## Urgent Field Safety Notice

794400008

### XQ series: Incorrect WBC result output to the host computer

<b>Product Name</b>	XQ-320; XQ-520
<b>Product Description</b>	XQ-Series Automated Hematology Analyzer
<b>Affected Serial No</b>	all
<b>Type of Action</b>	Advice given by manufacturer regarding use of the IVD
<b>FSCA-identifier</b>	794400008

**Figure 2:** Example screenshot of affected settings – the issue does occur.

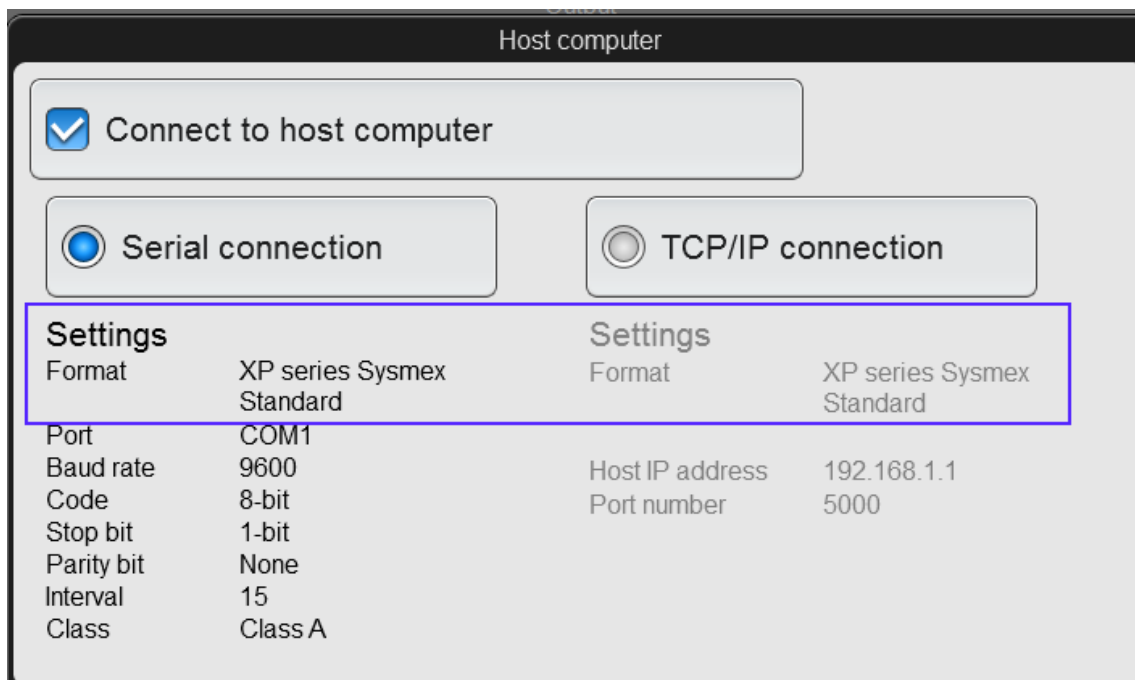
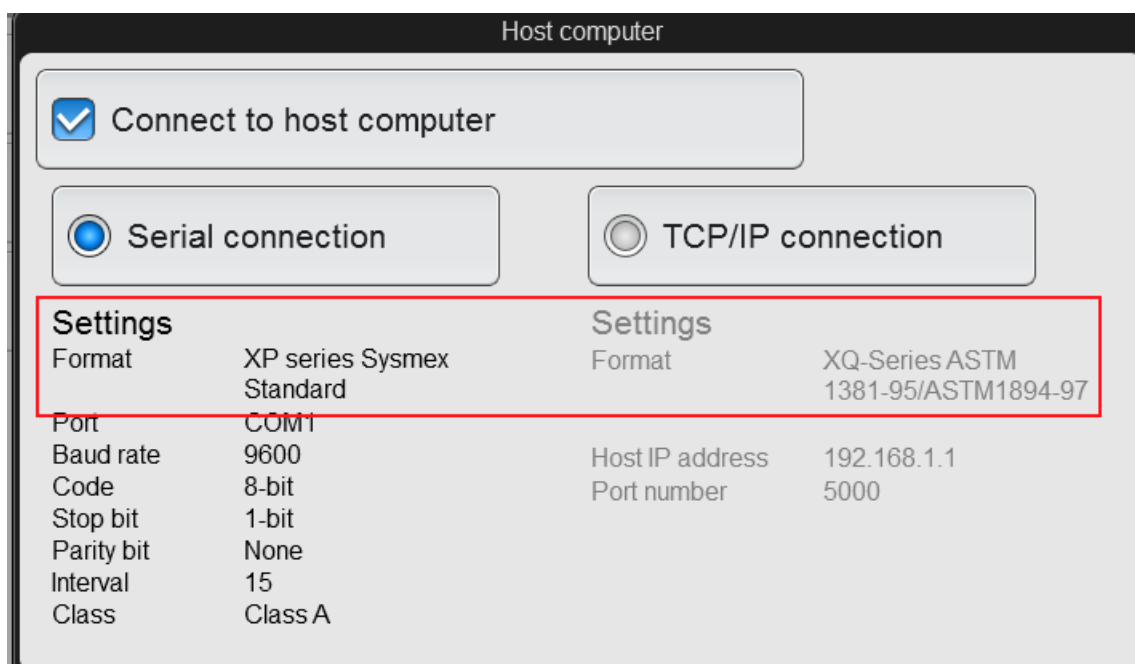
This malfunction occurs only when you use a serial connection and a legacy data transfer format (KX21N or XP series standard) and is caused by the **[Serial connection]** and **[TCP/IP connection]** settings not matching. Due to a software bug, the host format setting selected for TCP/IP is used, even when a serial connection is used.

**Figure 1:** Example screenshot of the correct settings – the issue does **not** occur.

1. Confirm whether the WBC results in the analyser software and in the LIS on the host computer match.
2. If WBC results do not match, that is, if WBC results on the host computers are higher by a factor of 10, change the host computer setting. The data format of **[TCP/IP connection]** must be the same as the data format of [Serial connection].
